SERVICE BULLETIN

N° **189-300**

ATA 28 - FILLER CAP CORROSION PROTECTION

This Service Bulletin provides the necessary instruction on how to improve the corrosion protection of the filler cap.

Figure 1

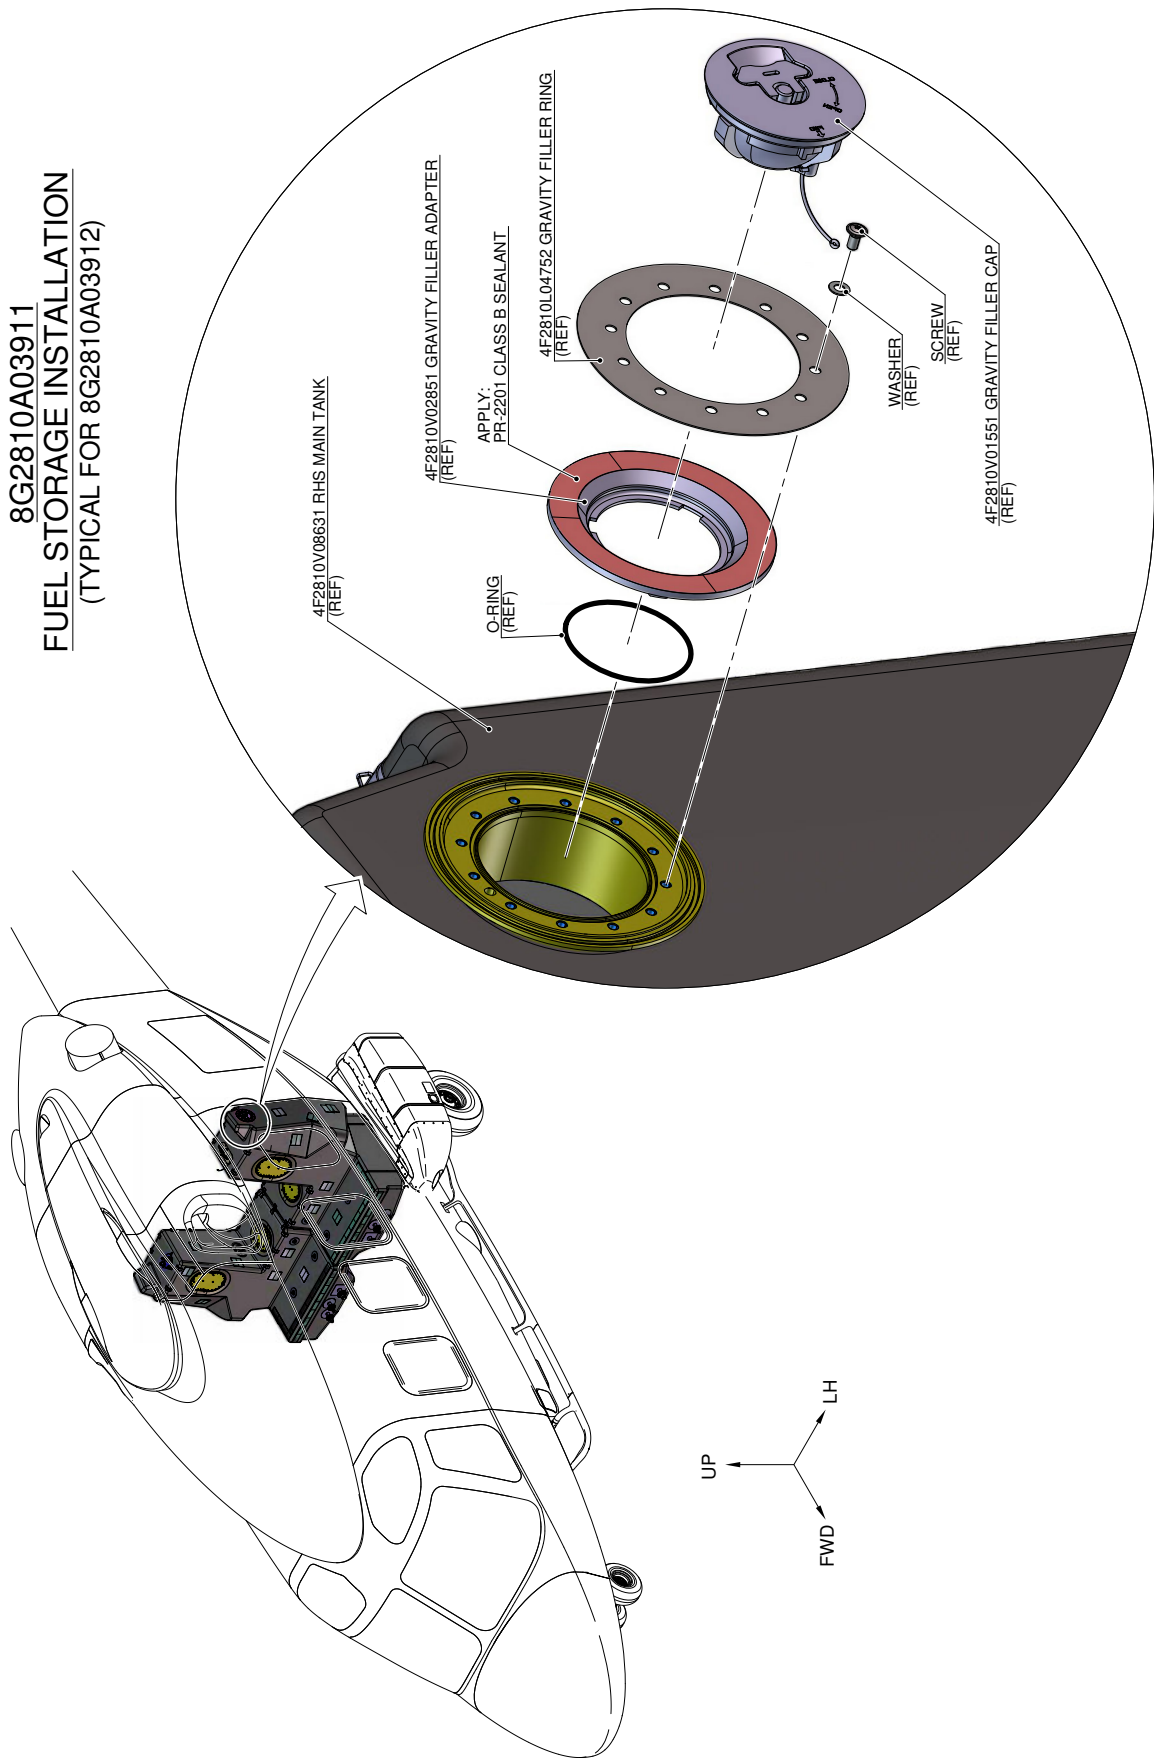
Apply sealant PR-2201 Class B between the filler ring P/N 4F2810L04752 and the filler adapter P/N 4F2810V02851. Make sure sealant does not overflow and does not cause problems when opening the filler cap P/N 4F2810V01551.

5. In accordance with AMP DM 89-A-28-11-19-00A-720A-A and with reference to Figure 1, re-install the filler ring P/N 4F2810L04752 and the filler adapter P/N 4F2810V02851 by means of the previously removed hardware (Ref. to Step 4).
6. In accordance with AMP DM 89-A-28-11-16-00B-720A-A and with reference to Figure 1, re-install the filler cap P/N 4F2810V01551 previously removed hardware (Ref. to Step 3).

Figure 2

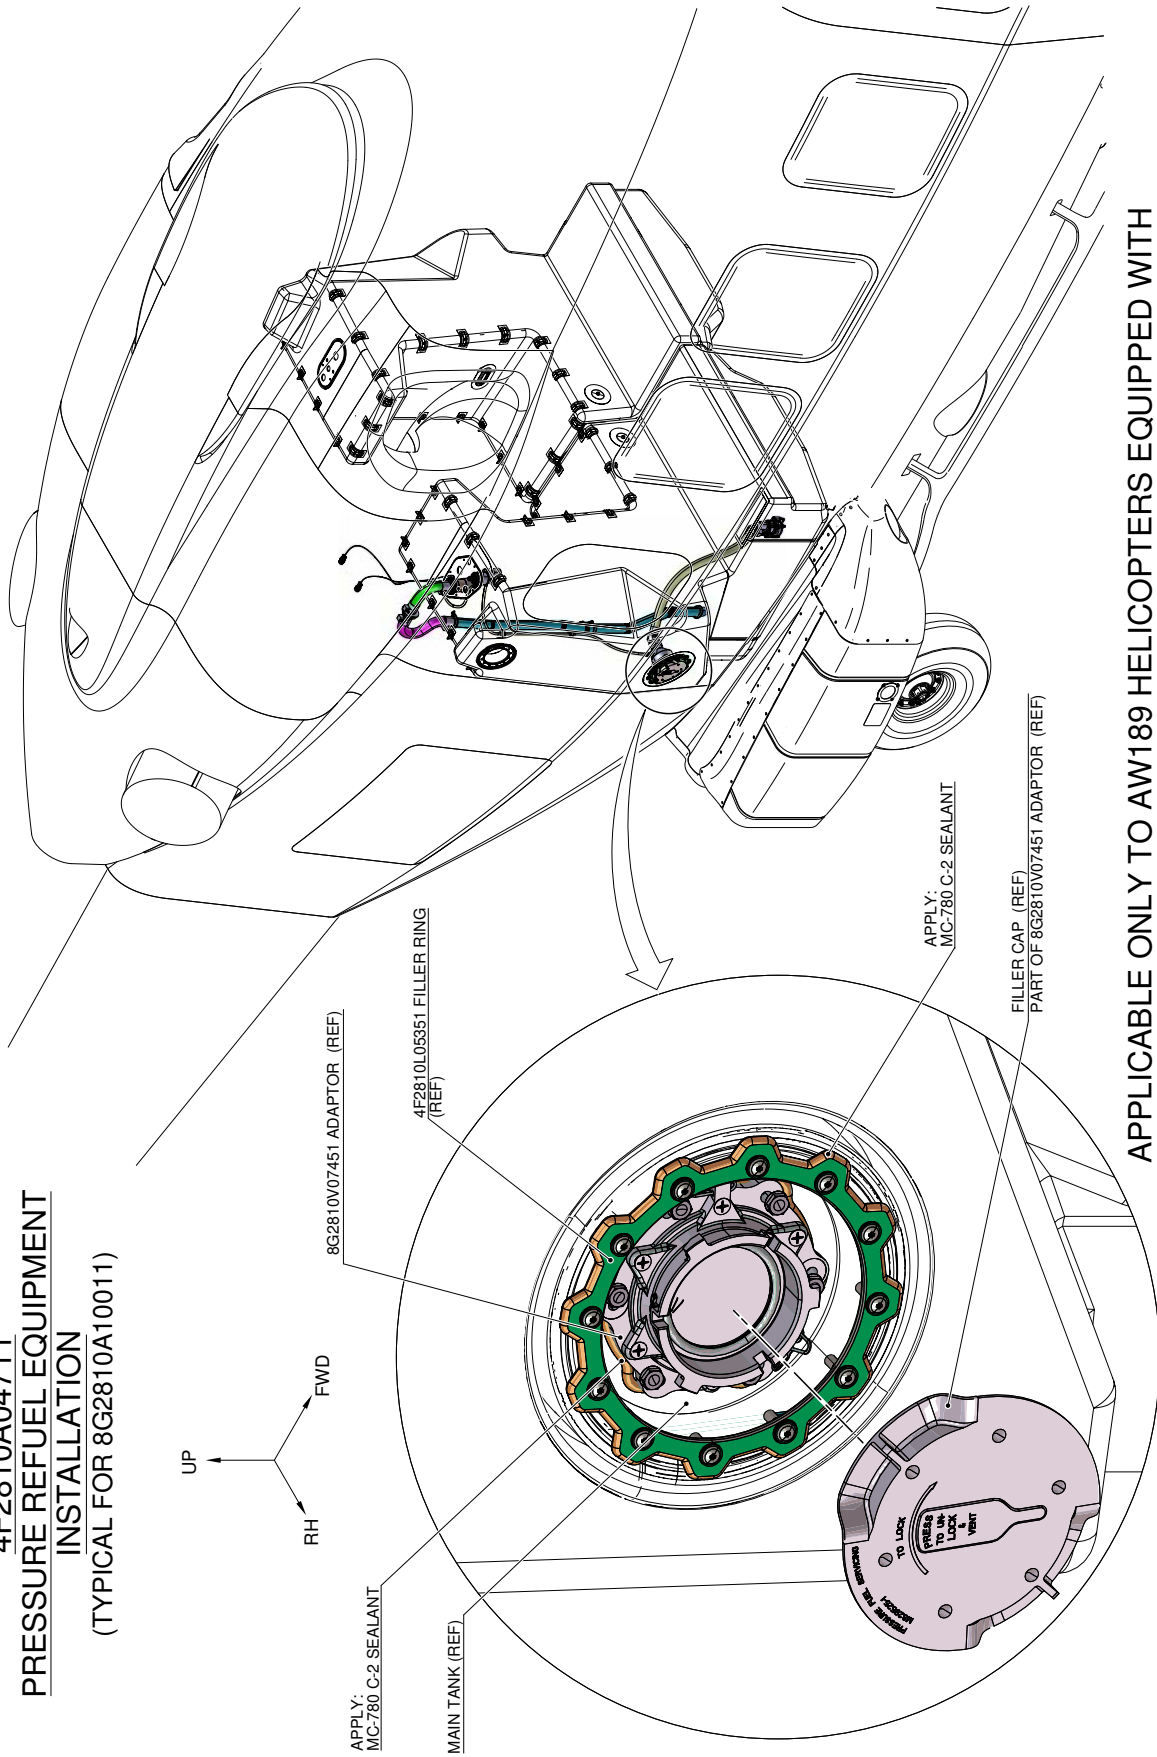
7. In accordance with applicable steps of AMP DM 89-A-12-11-01-00A-211A-A and with reference to Figure 2, remove the filler cap from the adaptor.

8. With reference to Figure 2, perform the corrosion protection with a full perimetrical sealing to the adaptor edge P/N 8G2810V07451 as indicated by means of sealant MC-780 C-2 (C465).
9. With reference to Figure 2, perform the corrosion protection with a full perimetrical sealing to the filler ring edge P/N 4F2810L05351 by means of sealant MC-780 C-2 (C465).
10. In accordance with applicable steps of AMP DM 89-A-12-11-01-00A-211A-A and with reference to Figure 2, re-install the filler cap on the adaptor.

12. In accordance with applicable steps of AMP DM 89-A-12-11-01-00A-211A-A and with reference to Figure 2, remove the filler cap from the adaptor.
13. With reference to Figure 2, perform the corrosion protection with a full perimetrical sealing to the adaptor edge P/N 8G2810V07451 as indicated by means of sealant MC-780 C-2 (C465).

14. With reference to Figure 2, perform the corrosion protection with a full perimetrical sealing to the filler ring edge P/N 4F2810L05351 by means of sealant MC-780 C-2 (C465).

15. In accordance with applicable steps of AMP DM 89-A-12-11-01-00A-211A-A and with reference to Figure 2, re-install the filler cap on the adaptor.
16. Return the helicopter to flight configuration and record for compliance with Part II of this Service Bulletin on the helicopter logbook.

Figure 3

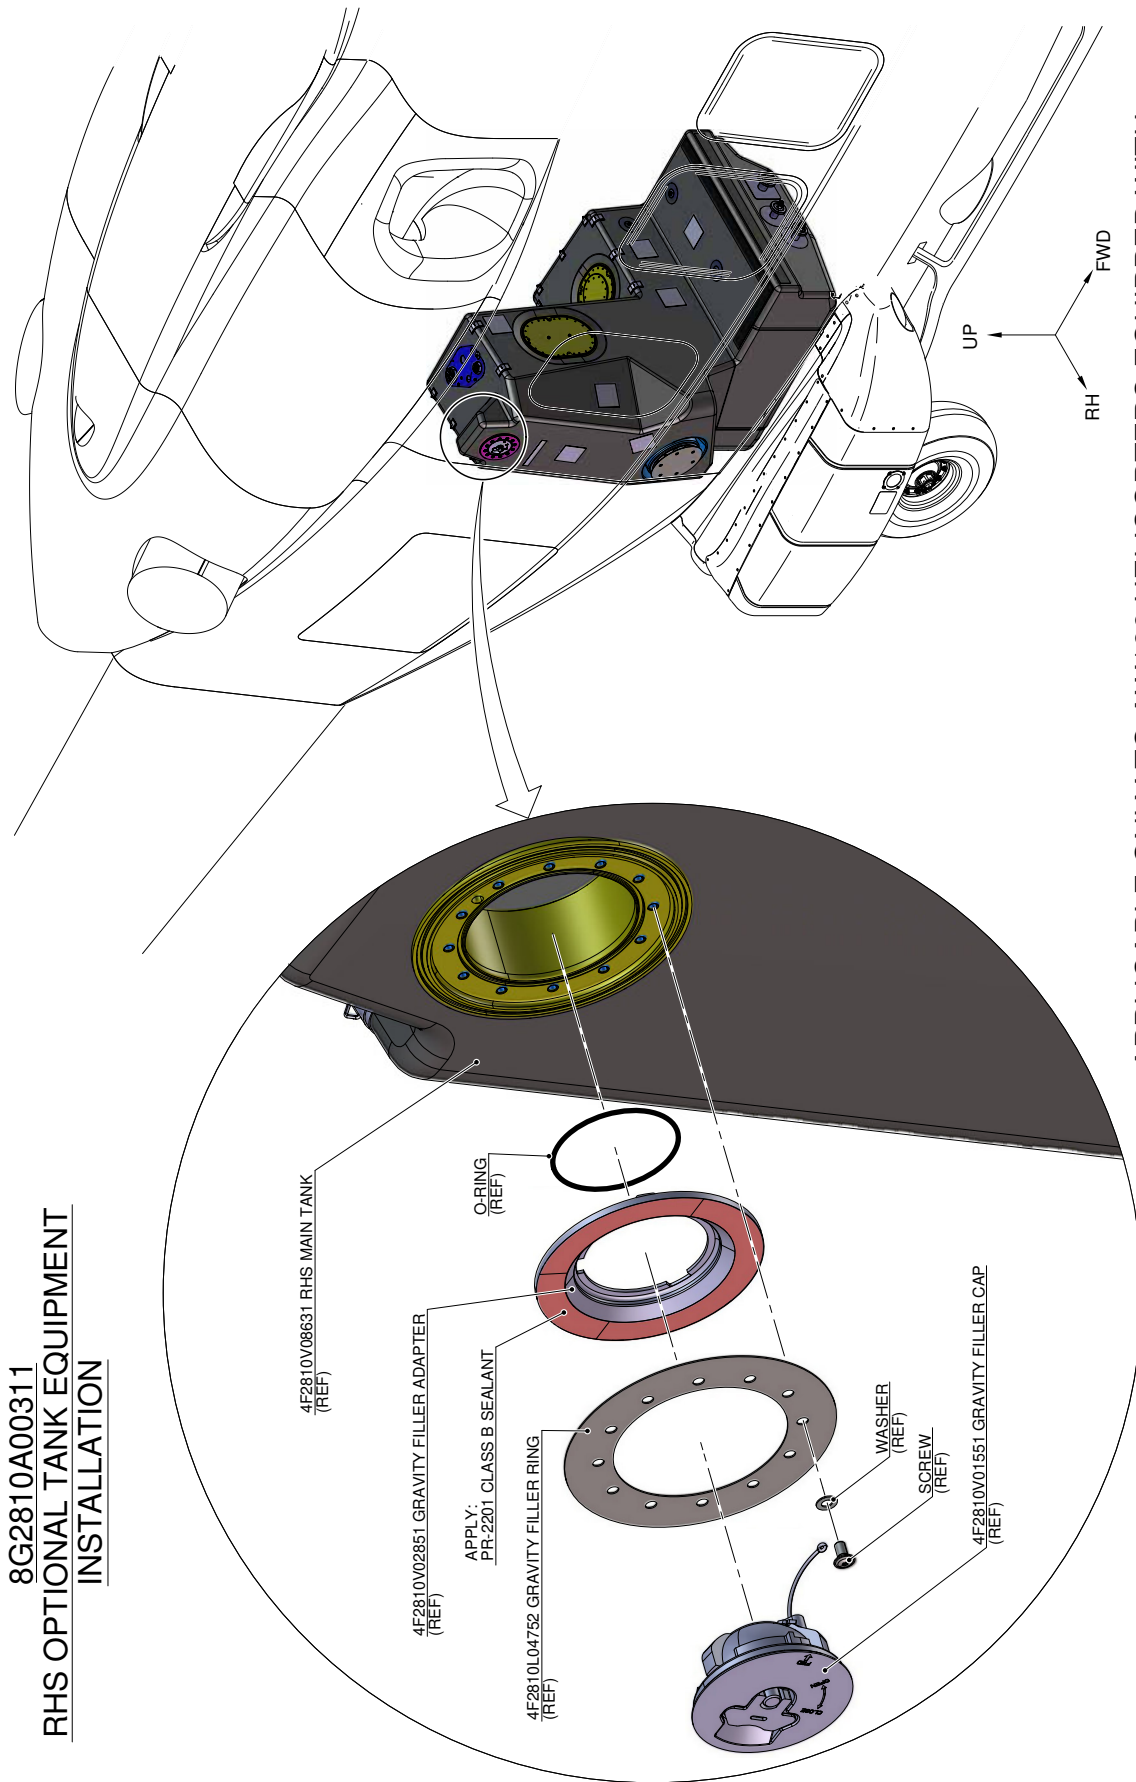
11. In accordance with AMP DM 89-A-28-11-16-00B-520A-A and with reference to Figure 3, remove the filler cap P/N 4F2810V01551.
12. In accordance with AMP DM 89-A-28-11-19-00A-520A-A and with reference to Figure 3, remove the filler ring P/N 4F2810L04752 and the filler adapter P/N 4F2810V02851 with the related hardware.

Apply sealant PR-2201 Class B between the filler ring
P/N 4F2810L04752 and the filler adapter
P/N 4F2810V02851. Make sure sealant does not
overflow and does not cause problems when opening
the filler cap P/N 4F2810V01551.

Figure 4

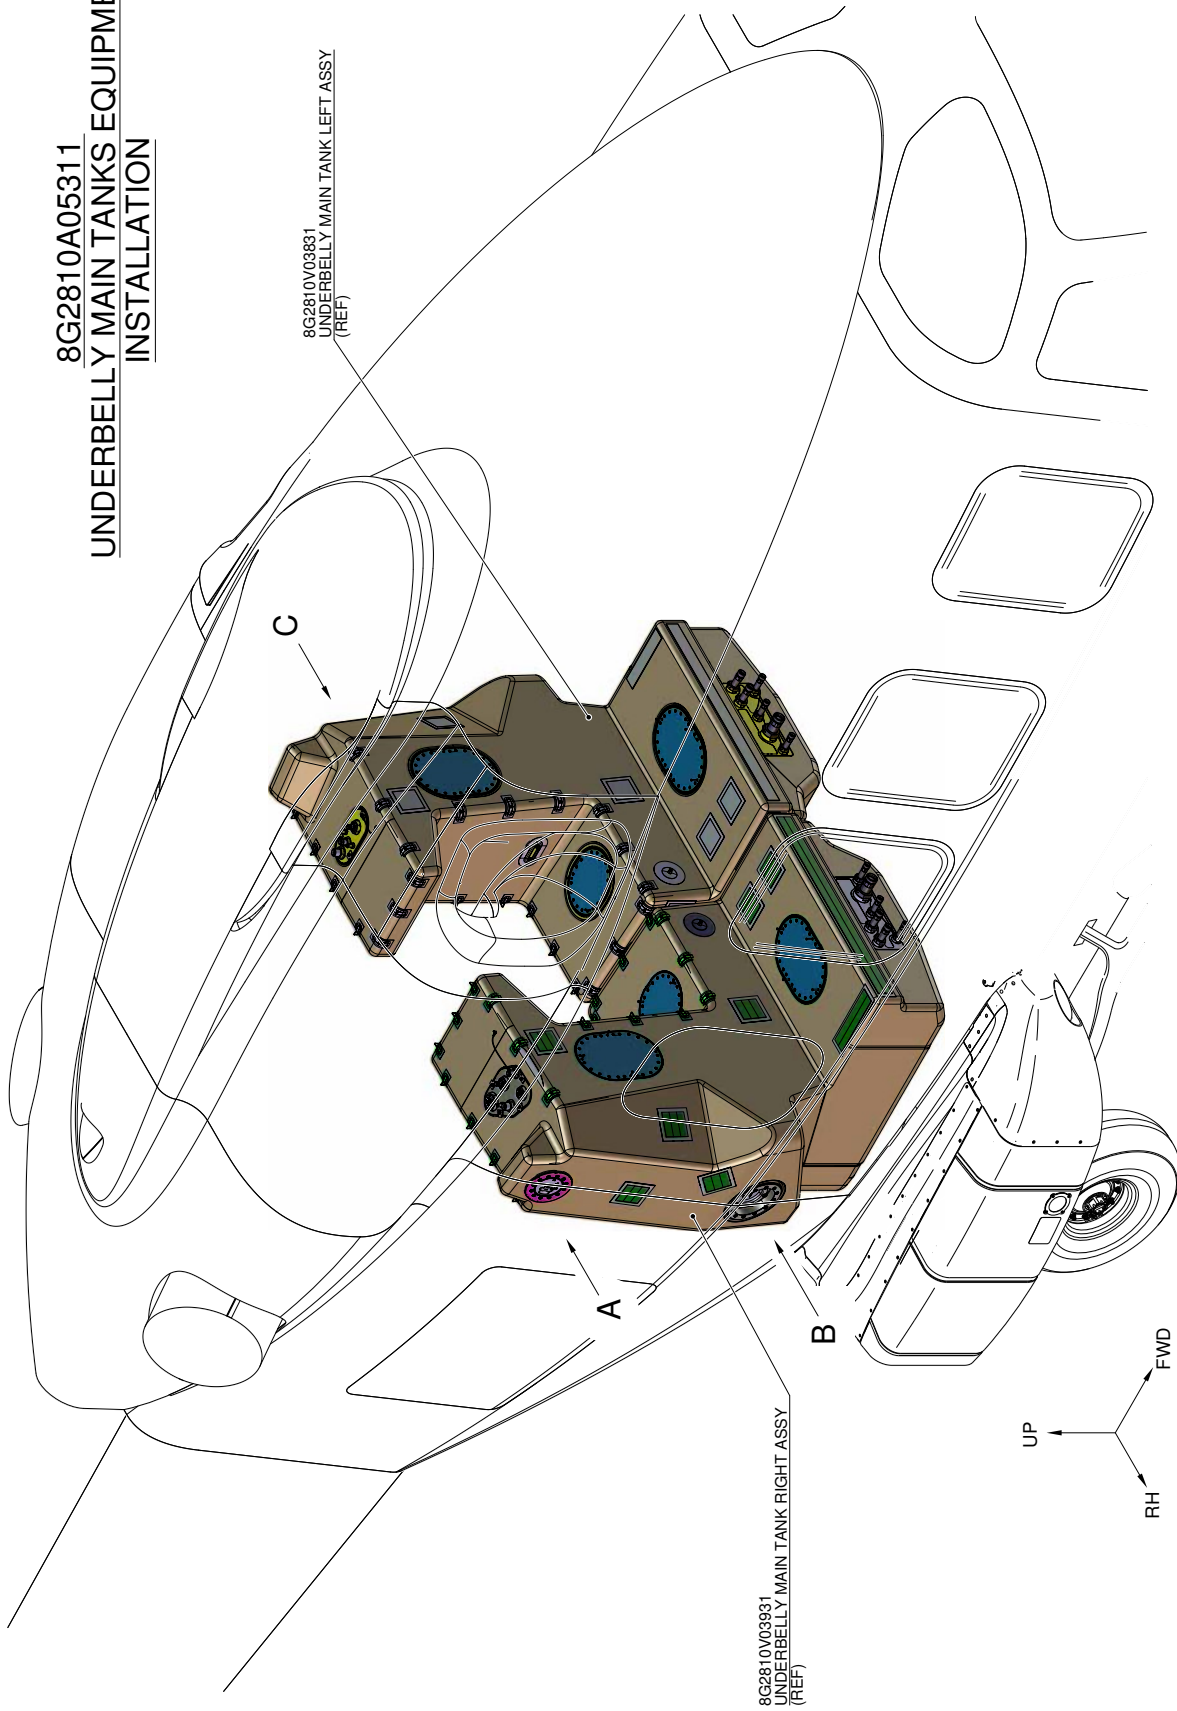
10. In accordance with AMP DM 89-A-28-11-16-00B-720A-A and with reference to Figure 5 View C, re-install the filler cap P/N 4F2810V01551 previously removed hardware (Ref. to Step 7).
11. With reference to Figure 4 and Figure 5 View B, if “kit pressure refuel” is not installed, perform the corrosion protection with a full perimetrical sealing to the blanking cap edge P/N 4499-294A and to the heads of n°6 bolts P/N NAS6604-5 by means of sealant MC-780 C-2 (C465).
